TO: Knoxville-Knox County Planning Commission
FROM: Samiul Haque, Planner
DATE: August 6, 2026
SUBJECT: Appeal of an administrative determination for a Middle Housing application
FILE #: 8-H-26-0B; Agenda Item #49

The applicant is appealing Planning staff's comments on a pending Middle Housing application for a proposed 3-unit structure at 1415 W Fifth Avenue (KnoxPlans project # IRC-NEW-25-0550).

1 ARCHITECTURAL SITE PLAN
3/16" = 1'-0"

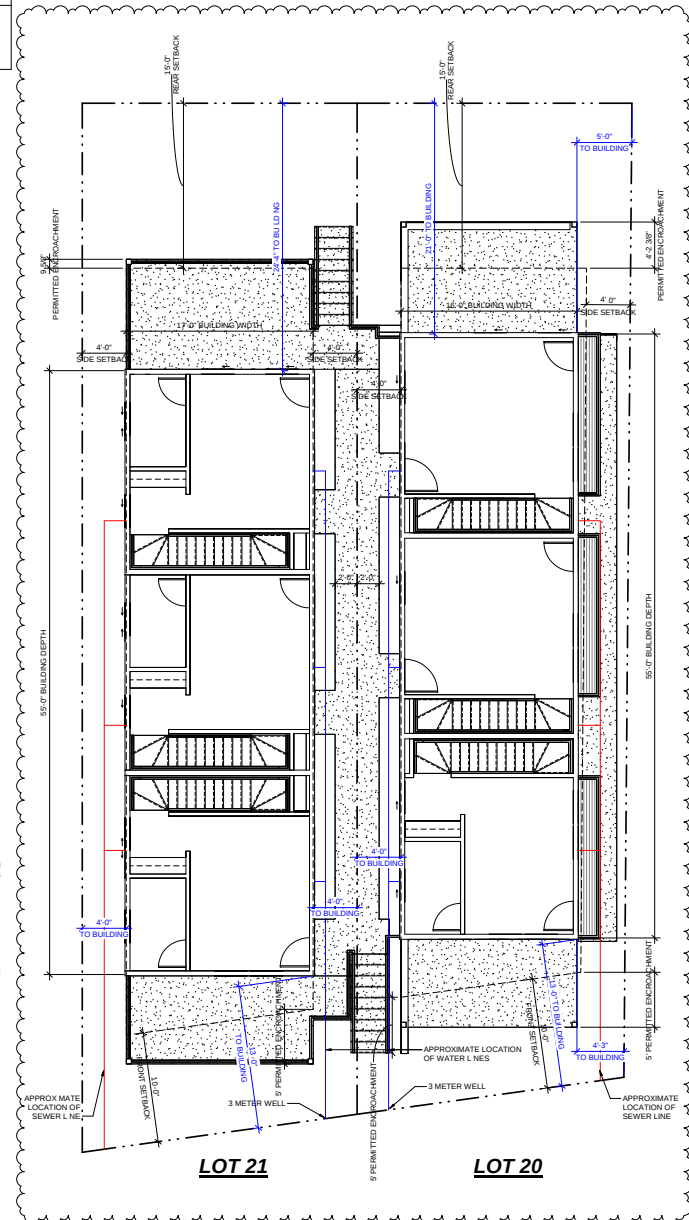
Comment				
		<i>Reviewer Response: Samiul Haque - 8/28/25 10:15 AM</i> See Ref. # 27			
		<i>Responded by: MARLOW BUILDERS - 8/19/25 3:40 PM</i> MH Approved by Planning Commission 8-3 on 14 August 2024. Agenda item 31; file 8C25OB.			
	Ref.# 29	Planning Review	Lindsay Lanois	7/29/25 1:36 PM	Cycle 1
	Resolved	Article 4.6.C: Provide an actual front setback measurement, measuring from the front property line to the front building line.

Comment				
		<i>Responded by: MARLOW BUILDERS - 8/19/25 3:40 PM</i> See revised A101.			
	Ref.# 30	Planning Review	Lindsay Lanois	7/29/25 1:36 PM	Cycle 1
	Resolved	Article 4.6.E.4.b: recesses or projections in the building wall of any front or side elevation that exceeds a length of 50, which shall be at least 2 wide. Side elevations do not meet this requirement.

EXTERIOR ELEVATIONS

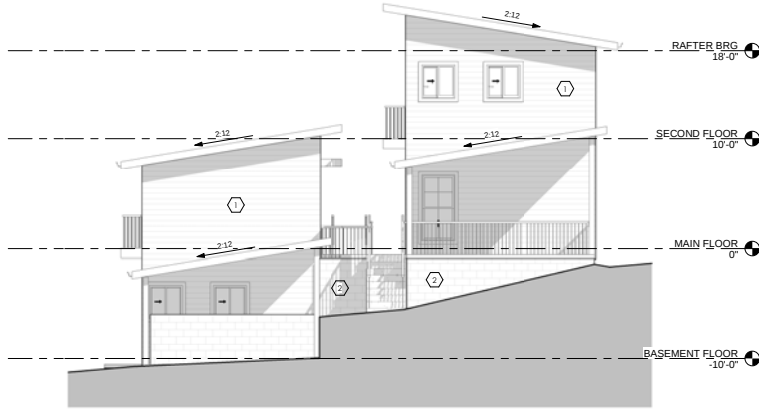
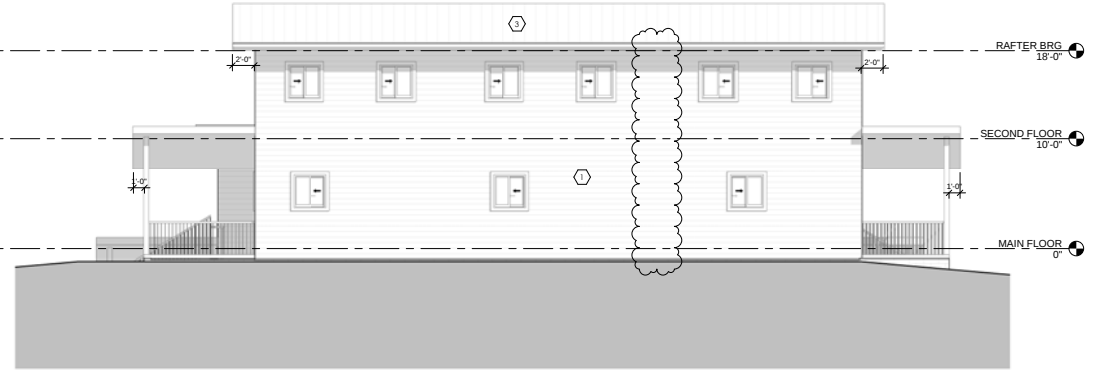
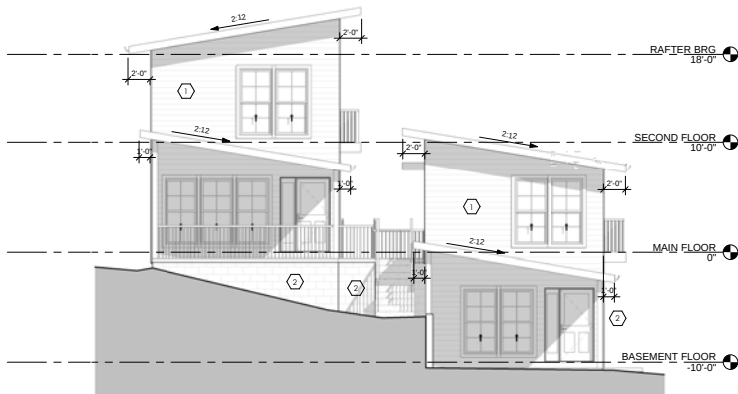
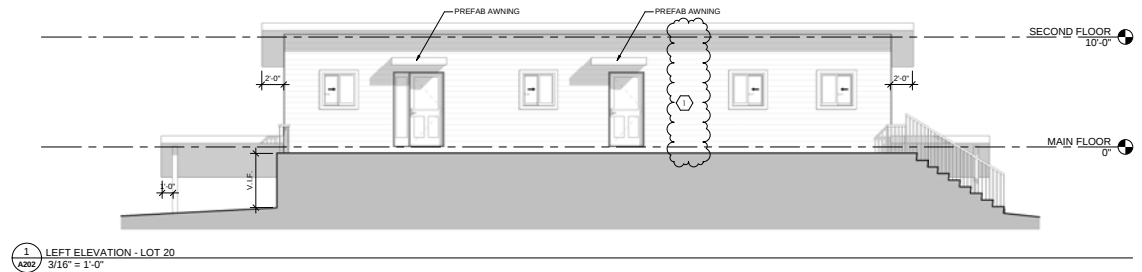
- 7/29/25 - Article 4.6.A: The applicant describes the building as a triplex. The application does not propose units that are stacked on top of each other and does not meet the definition of triplex. The building features three units oriented perpendicular to the street with the units separated by party walls/shared side walls, which meets the definition of a Dwelling Townhouse per Article 2.3 and partially meets the definition of Townhouse (small) per Article 4.6.A.
- 7/29/25 - Article 4.6.E.5.c: The proposed design does not meet the requirement that townhouses not be oriented perpendicular to the street. The narrow side of townhouse units must face the street.

<i>Responded by: MARLOW BUILDERS - 8/19/25 3:39 PM</i> MH Approved by Planning Commission 8-3 on 14 August 2024. Agenda item 31; file 8C25OB.			
	Ref.# 28	Planning Review	Lindsay Lanois	7/29/25 1:36 PM	Cycle 1
	Resolved	Article 4.6.E.5.c: The proposed design does not meet the requirement that townhouses shall not be oriented perpendicular to the street. The narrow side of townhouse units must face the street.

Comment				
		<i>Reviewer Response: Samiul Haque - 10/23/25 9:18 AM</i> An administrative variation has been approved in accordance with Article 4.6.G.1.iii. The removal of the faux chimney will contribute to a cohesive architectural design, and a reduction in setback encroachment will better align with the setbacks of neighboring buildings on the subject block face and the opposite block face across the street.			
		<i>Responded by: MARLOW BUILDERS - 10/13/25 9:08 PM</i> Planning staff can approve a variation to eliminate the requirement in Section 4.6.E.4.b. based on the criteria in Article 4.6.G.1.iii.			
		Section 4.6.E.4.b. Recesses or projections in the building wall are required in the horizontal plane of any front or side elevation that exceeds a length of 50 feet. Each recess or projection shall be at least two feet.			
		Article 4.6.G.1.iii. Design standards: a variation on the design standards in Section 4.6.E may be permitted, provided the project meets all applicable dimensional standards of Section 4.6, and variation from the design standards is necessary to achieve a creative architectural design which is similar in scale with the buildings on the subject block face and the block face directly across the street.
